Errata Document for TrueTouch® CY8CTMG200, CY8CTST200

CY8CTMG200 and CY8CTST200 Errata Summary

The following Errata items apply to the CY8CTMG200 and CY8CTST200 datasheets 001-47603 and 001-47602.

Figure 1. Eye Diagram

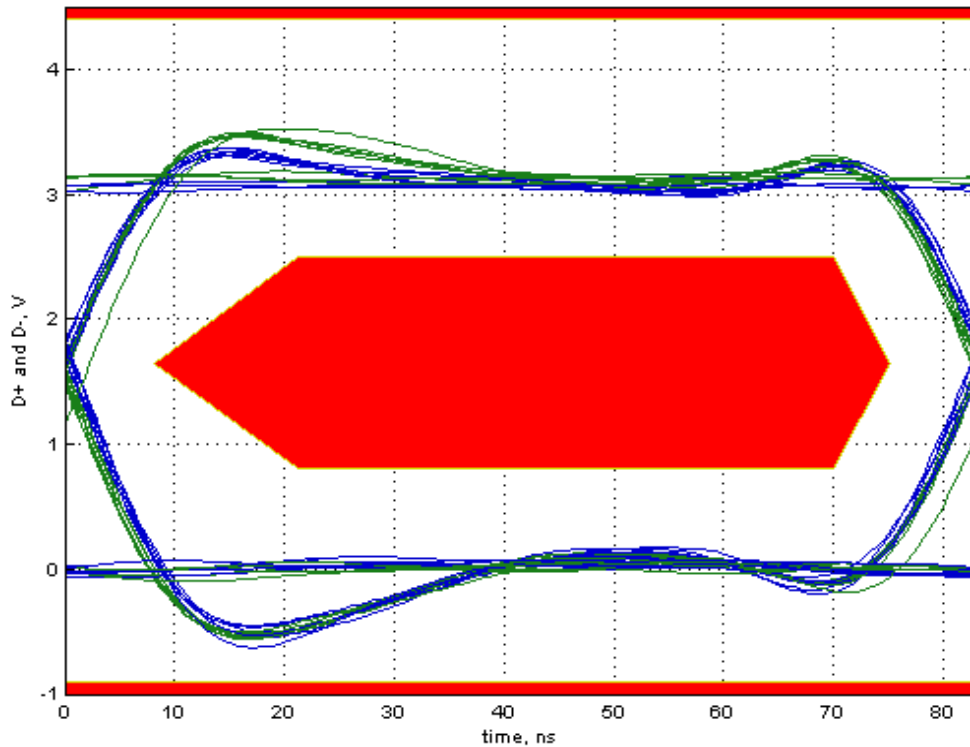
2. Does not meet USB 2.0 specification for D+ and D- rise/fall matching when supply voltage is under 3.3V

Rising to falling rate matching of the USB D+ and D- lines has a corner case at lower supply voltages, such as those under 3.3V.

Operating the VCC supply voltage at the low end of the chip's specification (under 3.3V) may cause a mismatch in the rising to falling rate.

This condition does not affect USB communications but could cause corner case issues with USB lines' rise/fall matching specification. Signal integrity tests were run using the Cypress development kit for the part and excellent eye was observed with supply voltage of 3.15V.

Avoid the trigger condition by using lower tolerance voltage regulators.

This issue will be corrected in the next new silicon revision.
